SERVICE BULLETIN

Service Bulletin No.: DA20-32-05 Rev. 2

Title: Replacement of Steel MLG Struts
with Aluminum MLG Struts

3. General: This Service Bulletin provides the procedures necessary to replace the Steel Main Landing Gear (MLG) struts installed on the aircraft with Aluminum MLG struts.

Figure 1 - Aluminum Main Landing Gear - Strut Installation

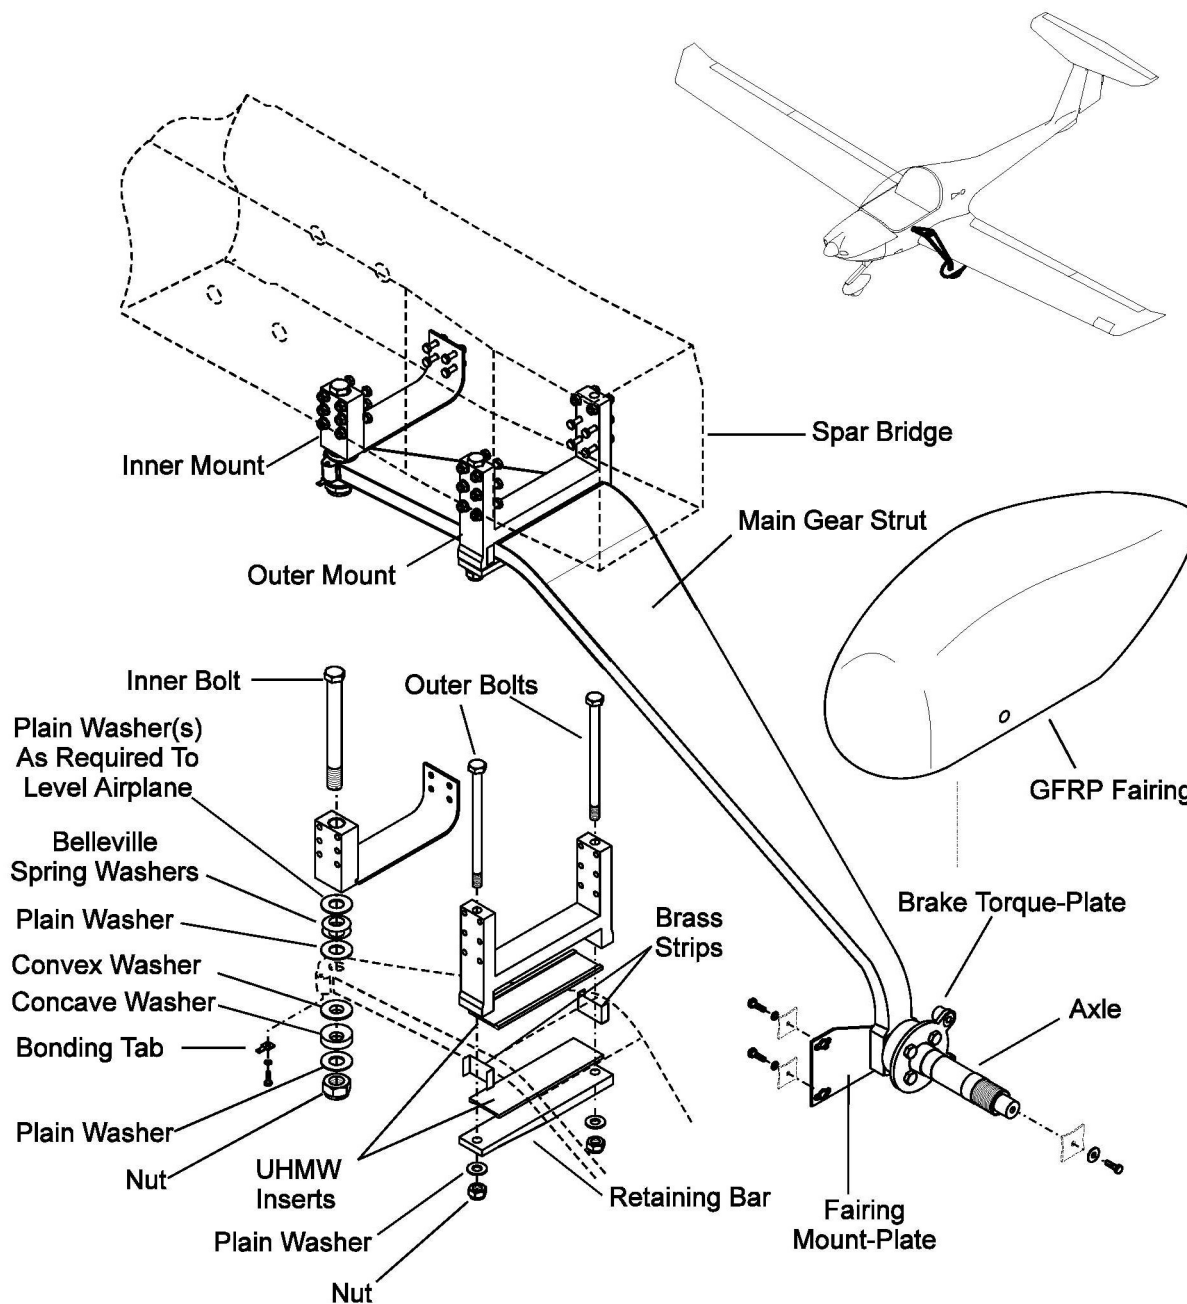
- 10.1 Put the aircraft on jacks. Refer to AMM # DA201-A1 Chapter 07-20.
- 10.2 Remove the steel MLG strut (P/N 20-3210-00-01) LH and the steel MLG strut (P/N 20-3210-00-02) RH.
Refer to AMM # DA201-A1 Chapter 32-10.
- 10.3 Install the aluminum MLG strut (P/N 22-3211-00-01) LH.
Refer to Figure 1, Figure 2, and the Parts Listing for the aluminum MLG.
 - 10.3.1 Examine the spar bridge in the area of the main gear mounting locations. Look specifically for damage to the GFRP structure.
Refer to AMM # DA201-A1 Chapter 51-10 for GFRP inspection procedures.
 - 10.3.2 Put the new strut in position.

- 10.3.14 Install the back-plate to the brake caliper.
 - 10.4 Repeat steps 10.3.1 to 10.3.14 to install the aluminum MLG strut (P/N 22-3211-00-02) RH.
Refer to Figure 1, Figure 2 and the Parts Listing for the aluminum MLG.

Figure 2, Sheet 1 - Aluminum Main Landing Gear

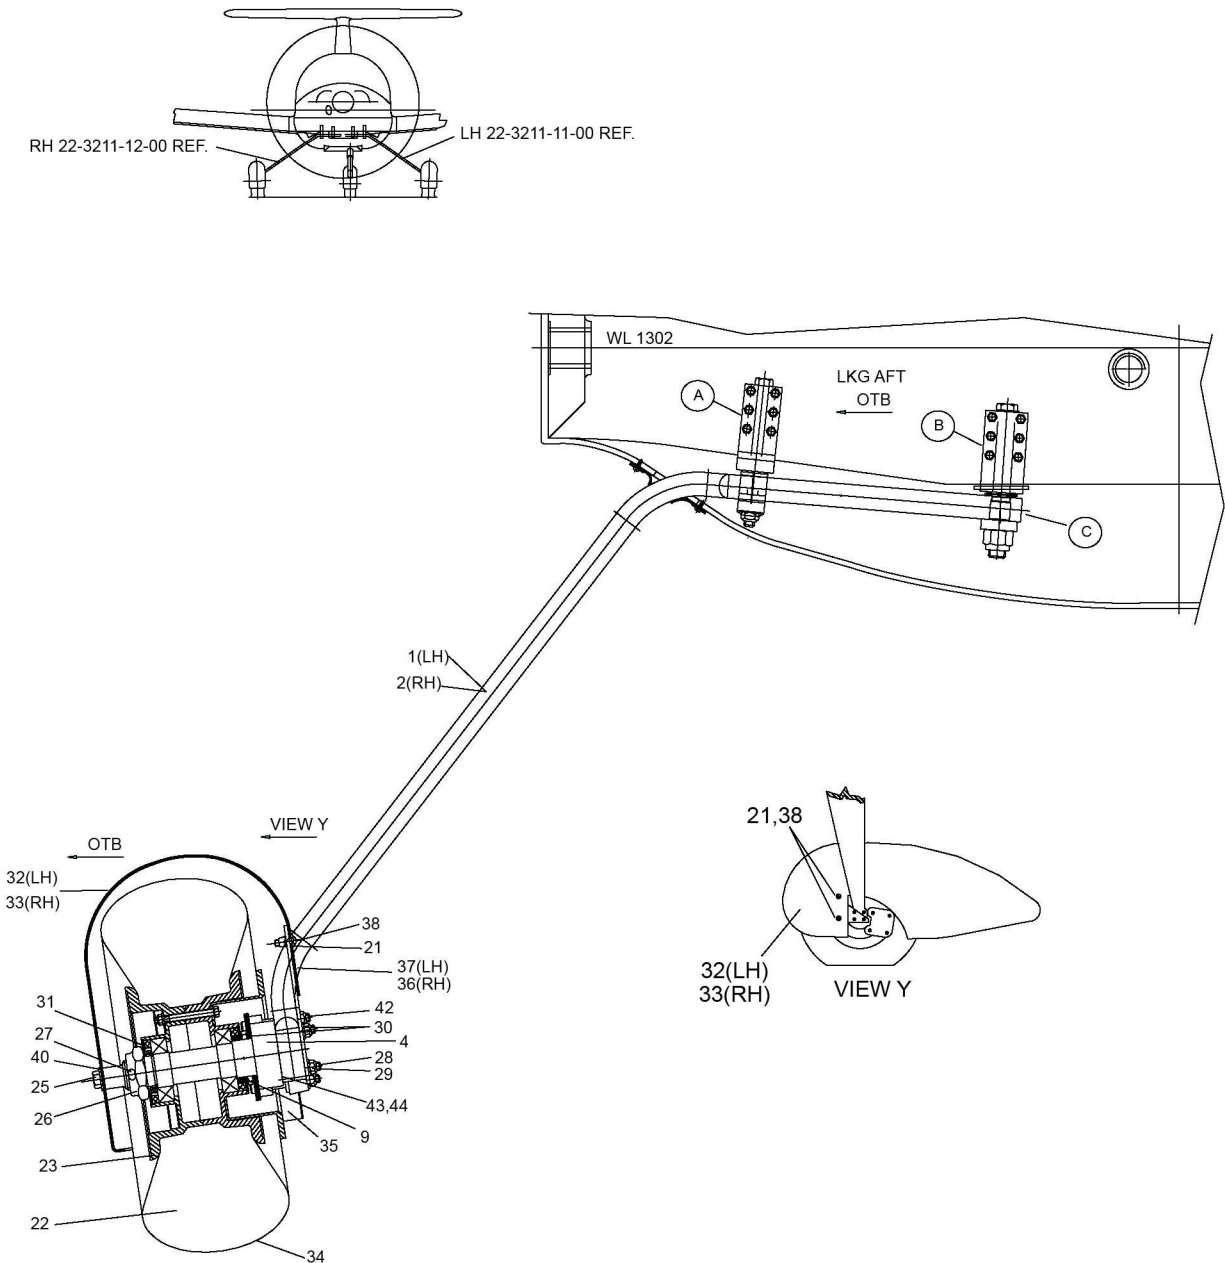
Revision 1 changes items 43 and 44 in the Parts Listing to be measured in degrees rather than inches and removes Item 45 (20-3210-10-00 - Dust, Boot Assembly) from Figure 2, Sheet 1 and the Parts Listing. The Dust, Boot Assembly can be re-used.
